Appendix 2 - Meeting notes from MCC pre-application discussions

Meeting notes from on site pre-application meeting 3rd December 2013
Present: Paul Mason- MCC
Toby Sproll- Bruntwood
Natalie Waldron- Living Ventures
Victoria Kirkpatrick- Bridge Architects

Meeting notes from on site pre-application meeting 19th March 2014;
Present: David Bretell - MCC
Paul Mason- MCC
Toby Sproll- Bruntwood
Peter Bearpark- Bruntwood
Victoria Kirkpatrick- Bridge Architects

drawing title Proposed Basement and Ground Floor Plans-Option 1
drawing scale 1:200 @ A3
drawing created November 2013
drawing rev -

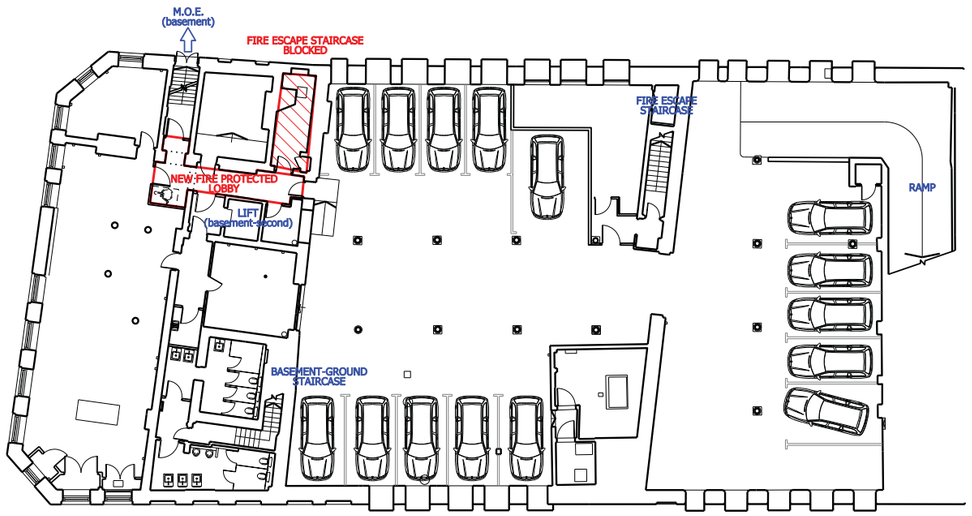
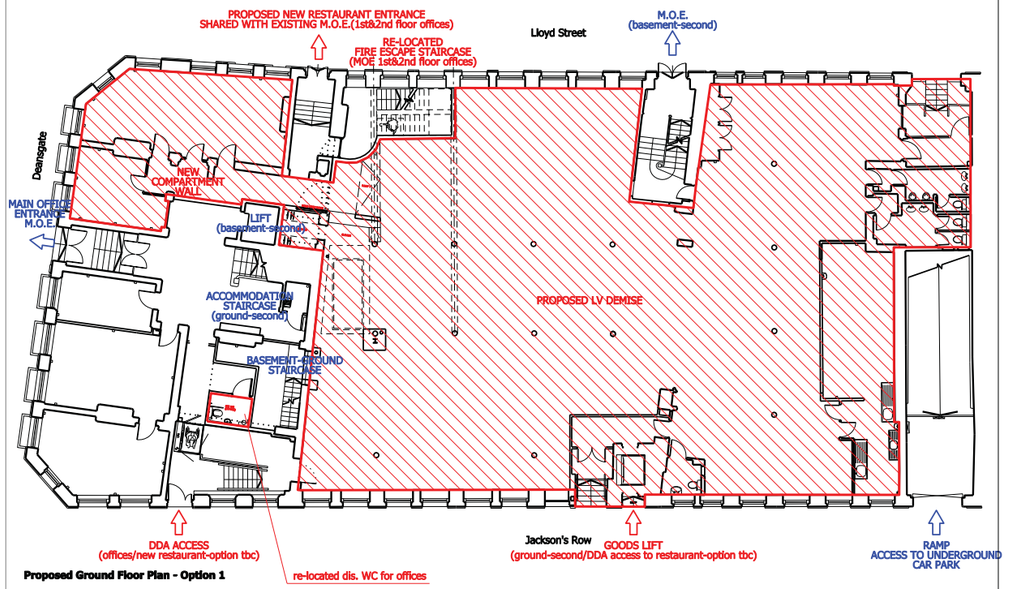
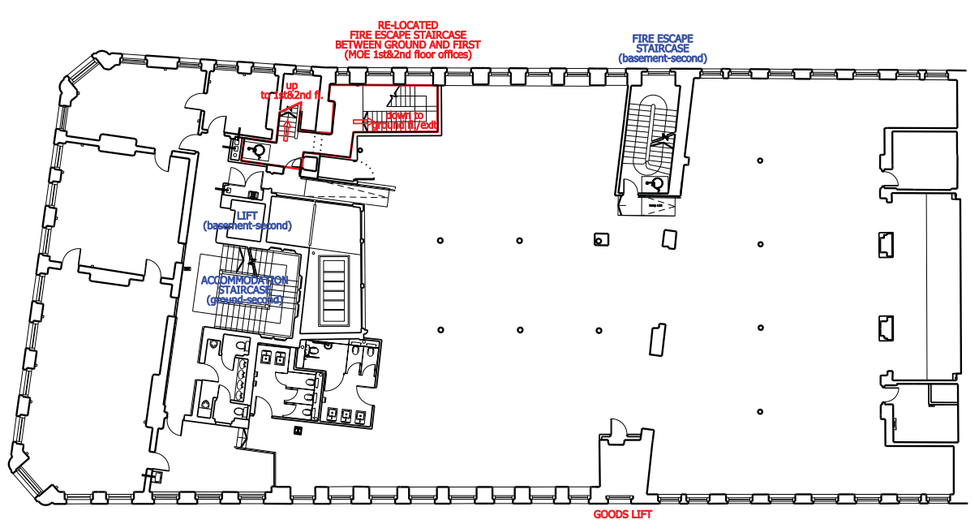
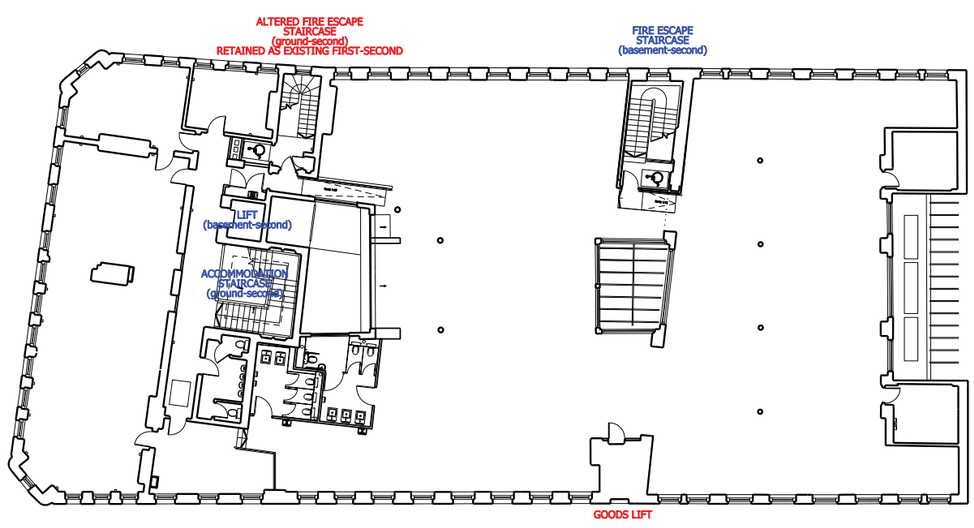
Three options were tabled and discussed at the meeting for the 'shell' works. Options 1 and 2 involved alterations to the existing means of escape staircases in the building. Option 3 involved minor elevational alterations to an existing entrance door and re-routing of an existing staircase (currently serving the basement) to the ground floor.

It was agreed that option 3 was the preferred solution in Conservation terms, and that the proposed new entrance would be considered appropriate if the existing 'Olive Press' entrance was 'downgraded' and re-instated to be in keeping with the original design. Precedent for the strategy for dealing with the new entrance already exists on the Jackson's Row frontage, where-by the existing fenestration pattern has been retained at high level with a 'minimal' glass door below. It was agreed that this would be the preferred design aesthetic for the new entrance door.

project	Elliot House
client	Bruntwood
job no.	0176
drawing no.	SK010
drawing title	INTERVENTION C- ENTRANCE LOBBY ALTERATIONS: OPTION C1
drawing scale	
drawing created	March 2014
drawing rev

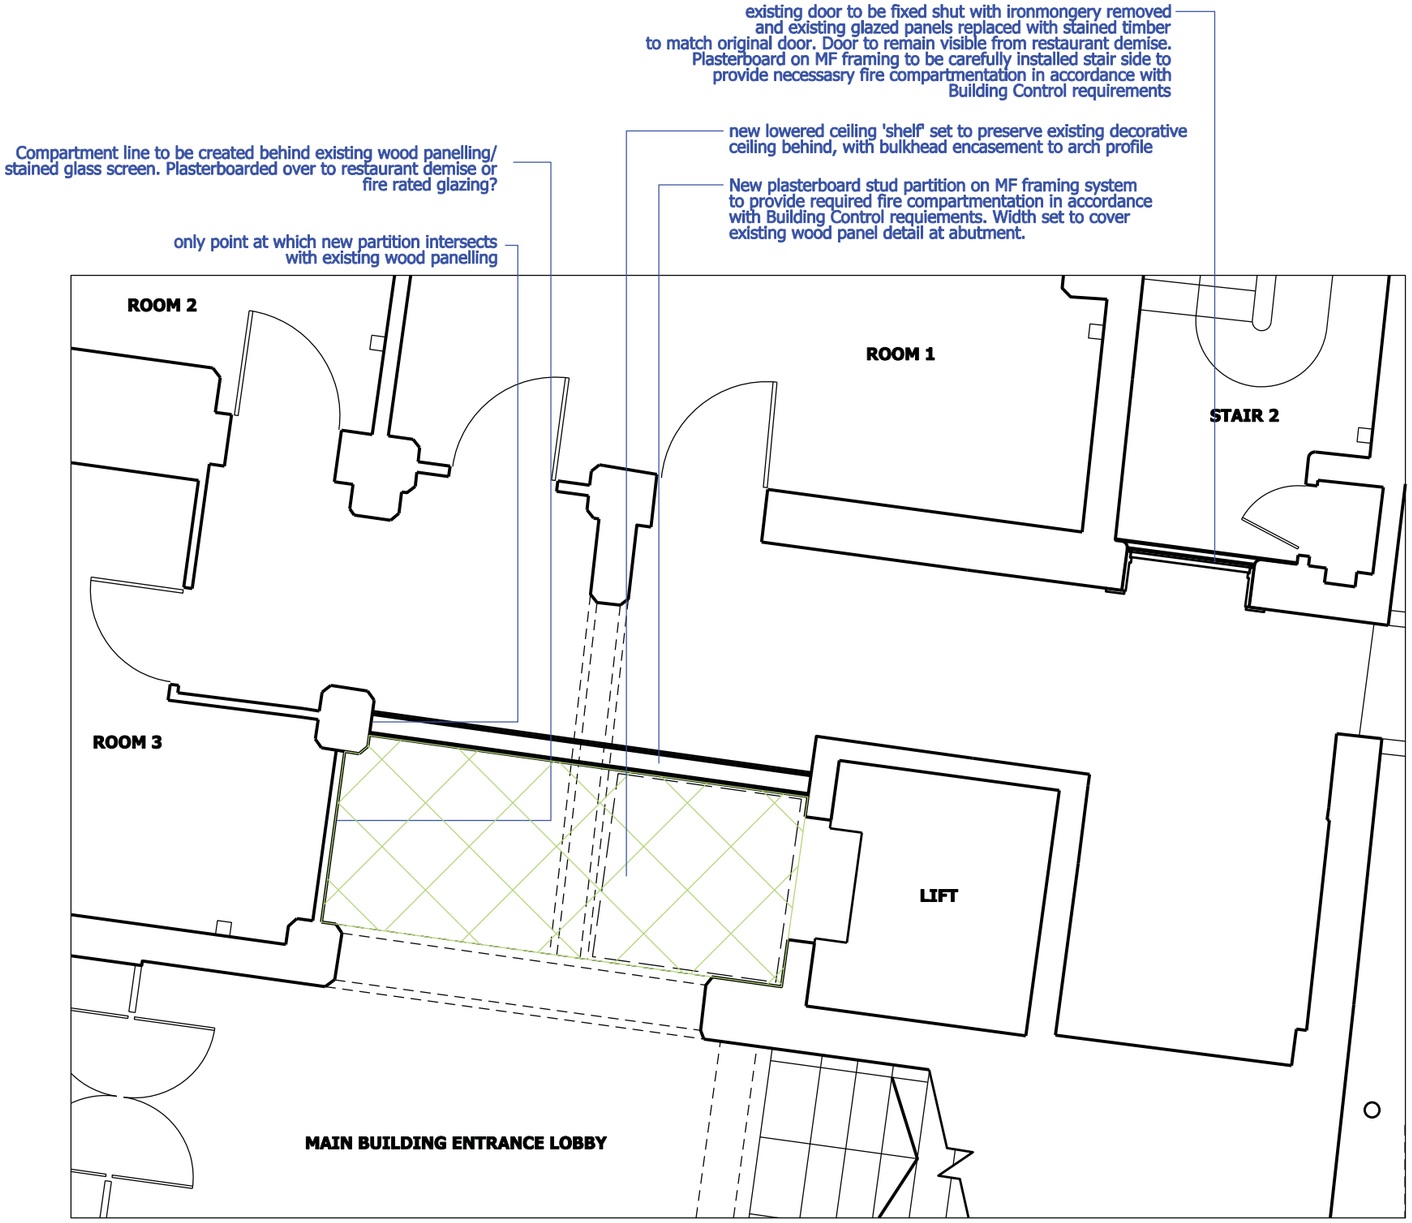
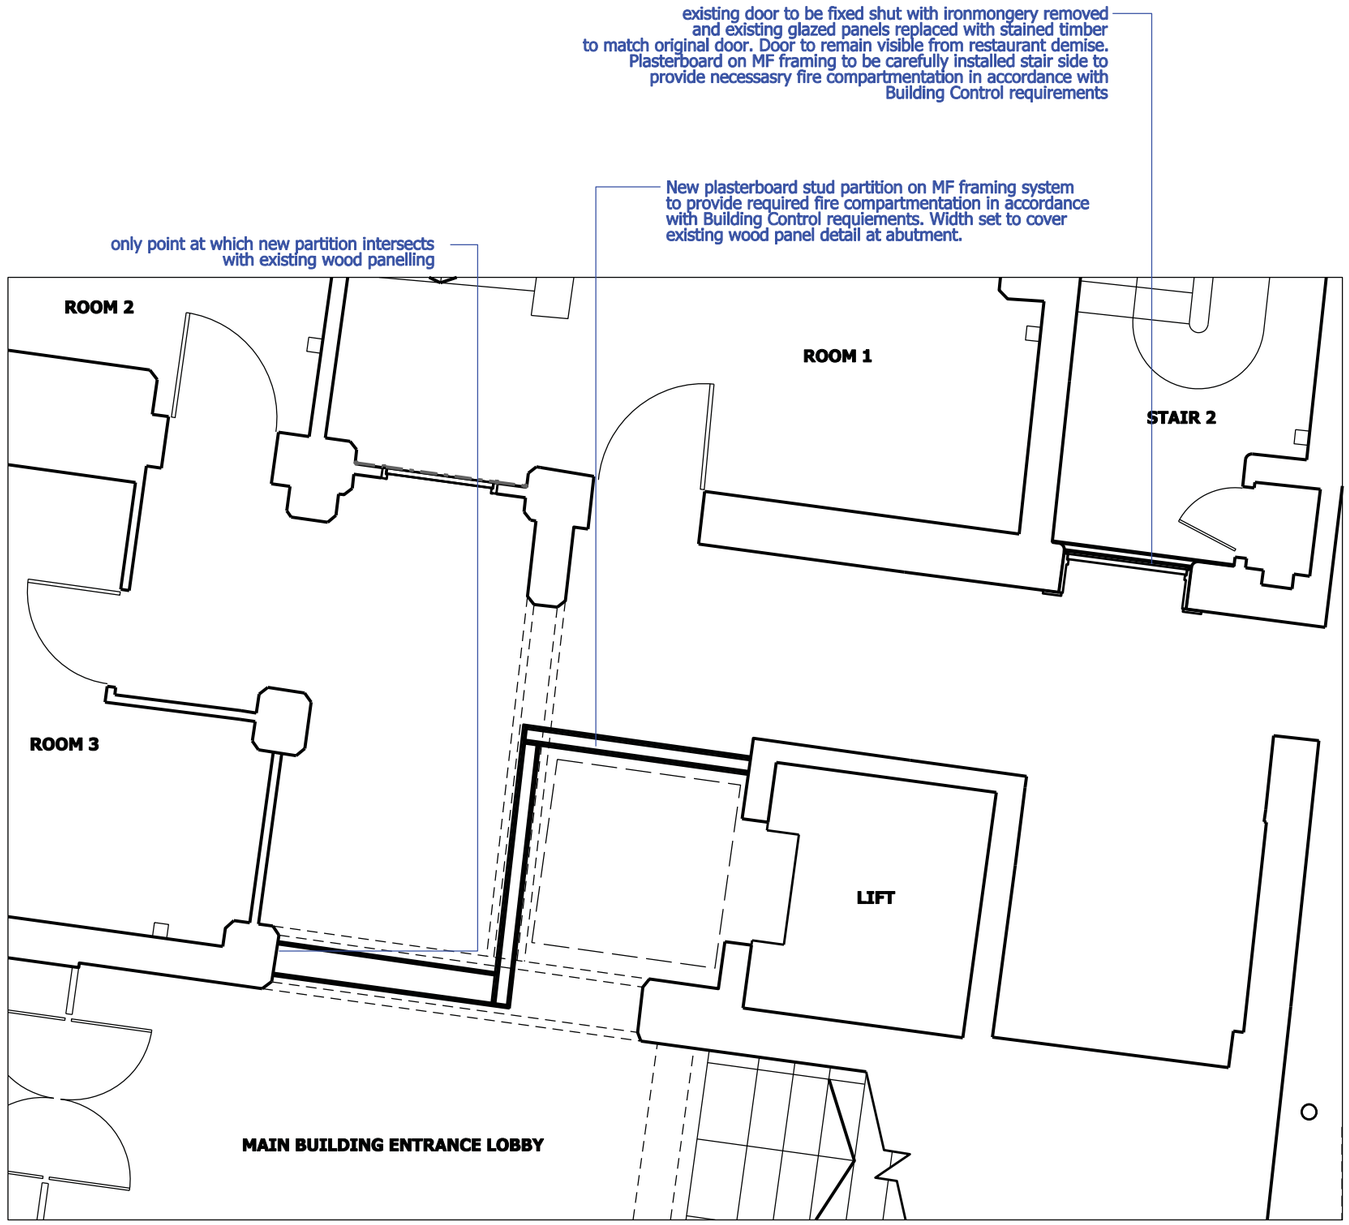
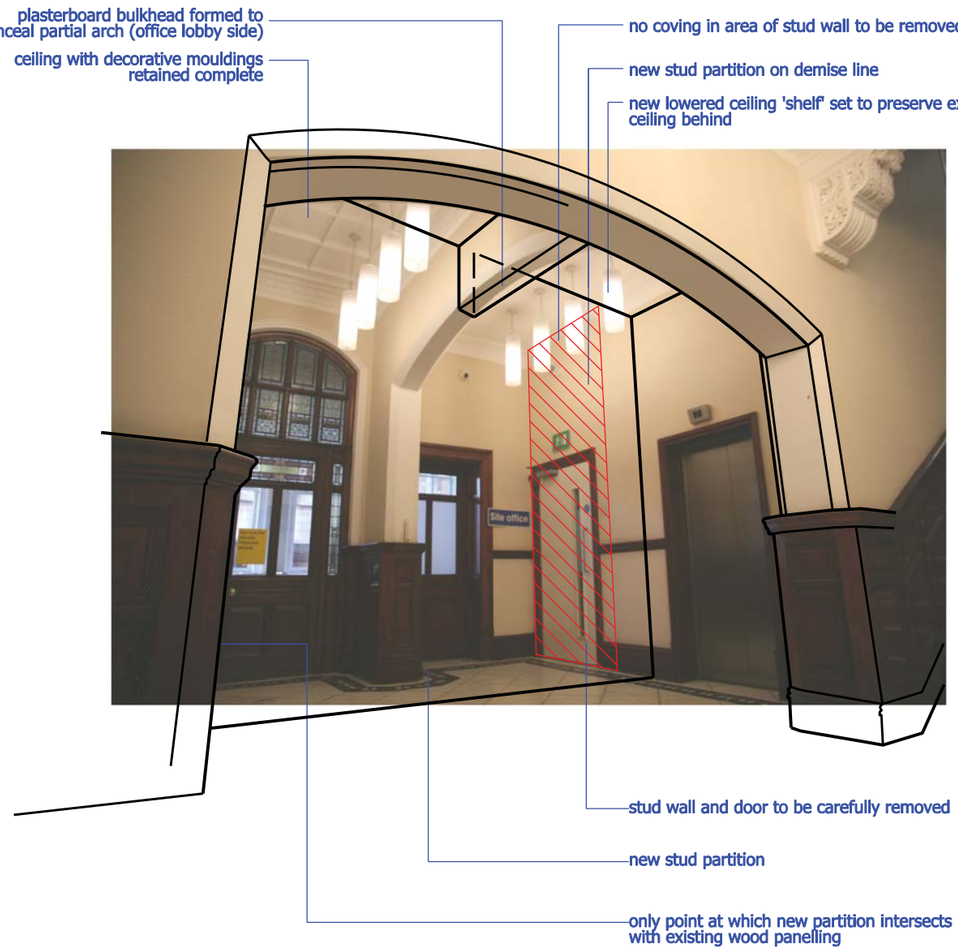
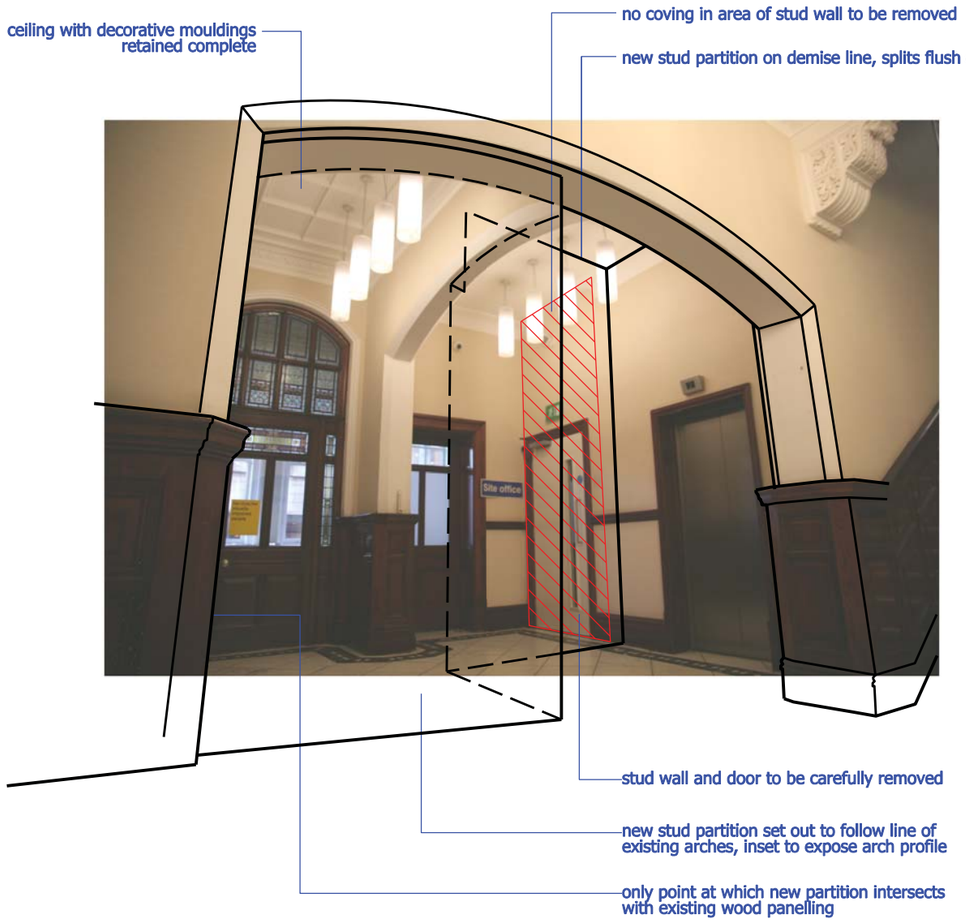
- Restaurant demise/ entrance lobby split; two options were tabled for the proposed new restaurant demise line that would achieve the brief requirements for the Deansgate fronting rooms. DB and PM considered both to be unacceptable in terms of detriment to the historic building fabric. It was noted that as the position of the new restaurant entrance was critical to the tenants operation/ lease negotiations, so re-consideration would be given to the requirement for the Deansgate fronting rooms, in order to achieve a more sensitive solution to the new demise line. On the basis of this, two further possible scenarios were discussed for this area, which PM and DB advised were likely to be considered more acceptable than current proposals.
